Re: file 0ZS 21 – 011 151 Bristol Street Guelph

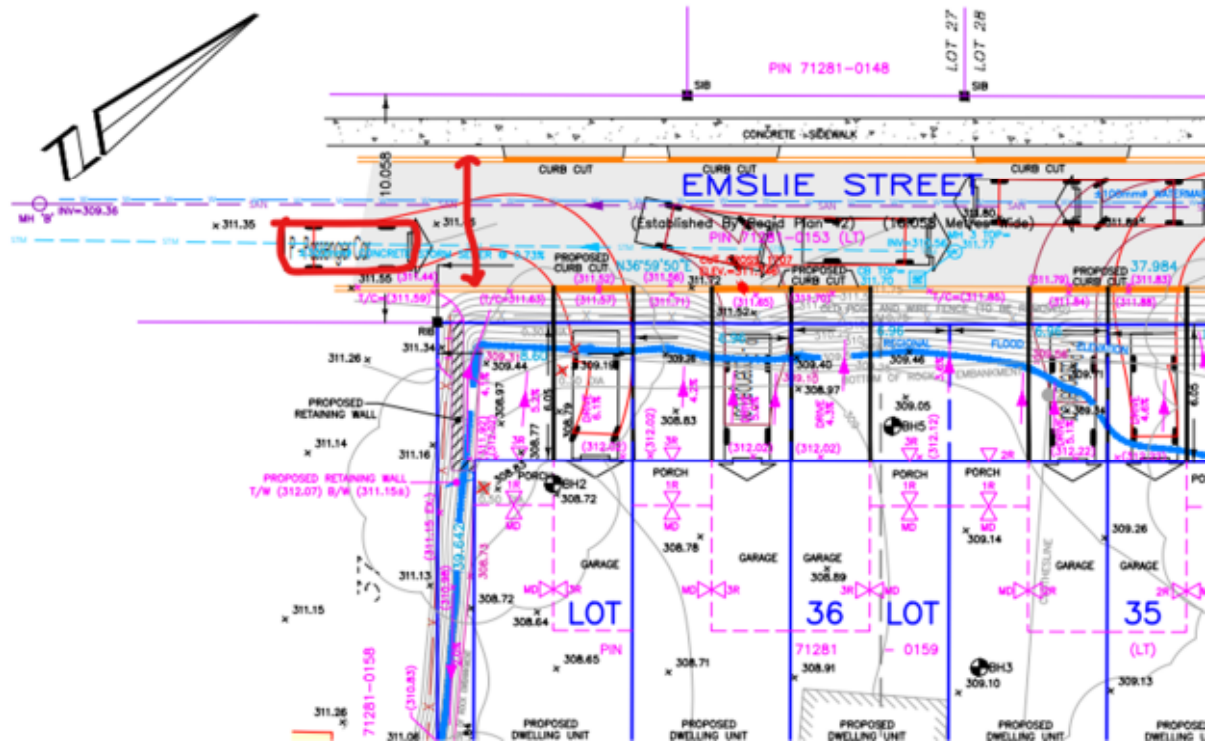
Item i) is somewhat misleading. The front of the townhouses on Emslie Street will be two stories high. On this portion of Emslie Street, the immediately adjacent house is only one story and almost all the houses directly across the are older bungalows. More significantly because the proposed townhouses have basement walkouts, the portion that backs onto Bristol Street will be three stories high not including the roof. In addition, all the houses on Bristol and Emslie Street are older and the modern appearance of the townhouses will certainly not be compatible with

the adjacent houses. Imagine walking along an older residential street with a lush tree canopy and suddenly coming upon a three- story monolith with all of the mature trees removed from the property. Imagine living in the small bungalow next door and being used to seeing trees and an appropriate for the neighborhood bungalow next door. If this rezoning to R.3 goes ahead, the view from the houses on either side will be dominated by two stories of brick topped by another 3m of vinyl siding.
